Metropolitan Historic Zoning Commission
Sunnyside in Sevier Park
3000 Granny White Pike
Nashville, Tennessee 37204
Telephone: (615) 862-7970

STAFF RECOMMENDATION
2510 Oakland Avenue
June 17, 2020

Application: New Construction—Addition and Outbuilding/detached accessory dwelling unit; Partial Demolition
District: Belmont-Hillsboro Neighborhood Conservation Zoning Overlay
Council District: 18
Base Zoning: R8
Map and Parcel Number: 11704001900
Applicant: Martin Wieck, Nine12 Architects
Project Lead: Melissa Sajid, Melissa.sajid@nashville.gov

Figure 4. Right-side façade.

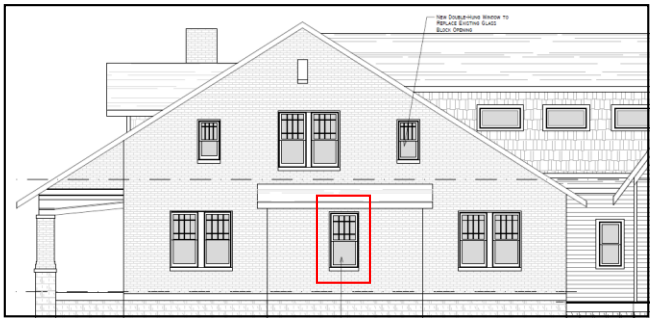
The plan also proposes to alter a window opening on the right-side façade of the historic house (Figures 4 and 5). The window on the lower-level bay is to be elongated. Staff finds that the proposed alteration can be appropriate in this case given the location of the window opening around the midpoint.

1 Site Plan

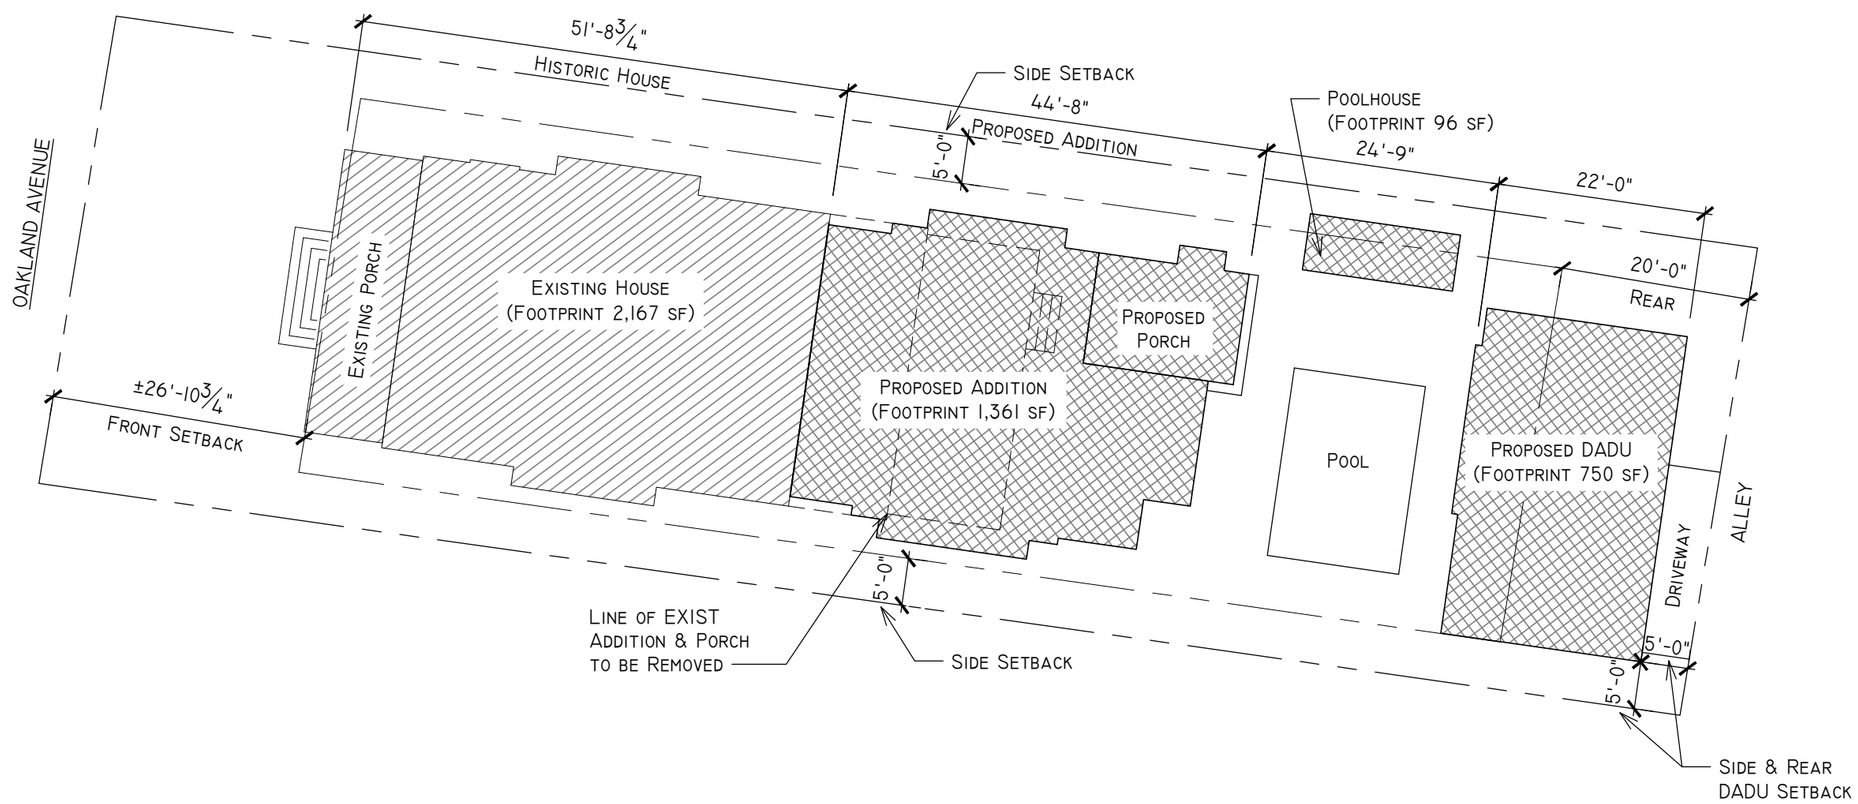
1. Prior to issuance of a preservation permit, the site plan shall be revised to show the pergola that is attached to the pool house and the shower that is attached to the DADU;
2. Staff approve the final details, dimensions, and materials of roofing and doors for the addition prior to purchase and installation;
3. Staff shall approve the final details, dimensions, and materials of the pool house prior to purchase and installation;
4. Staff approve the final details, dimensions, and materials of roof materials and color, windows, doors, and garage door for the DADU prior to purchase and installation;
5. The siding shall be smooth face; and
6. The HVAC shall be located behind the house or on either side, beyond the mid-point of the house.

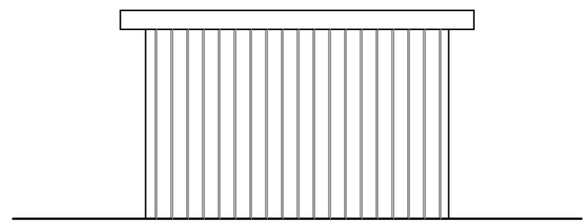
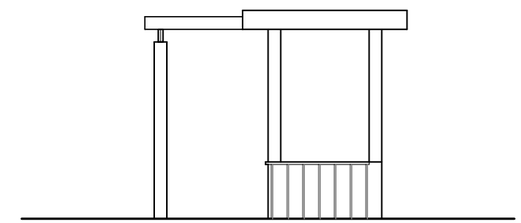
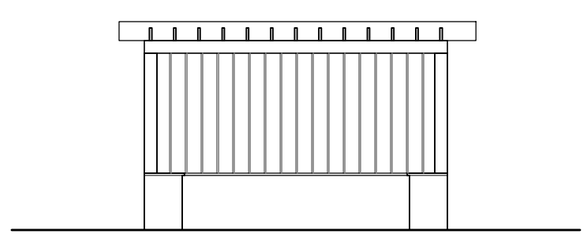
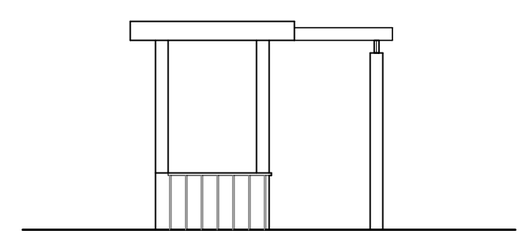
The materials for the pool house were not noted on the plans. With staff's final approval of all materials for the pool house as well as the roof material and color, windows, doors, and garage door for the DADU, staff finds that the materials meet the design guidelines.

**The proposed pool house is located approximately five feet (5') from the addition and four feet (4') from the DADU. Staff finds that the location of the pool house can be appropriate since its location is offset from the addition and DADU and its footprint is small at approximately one hundred seventy-five square feet (175 sq. ft.).
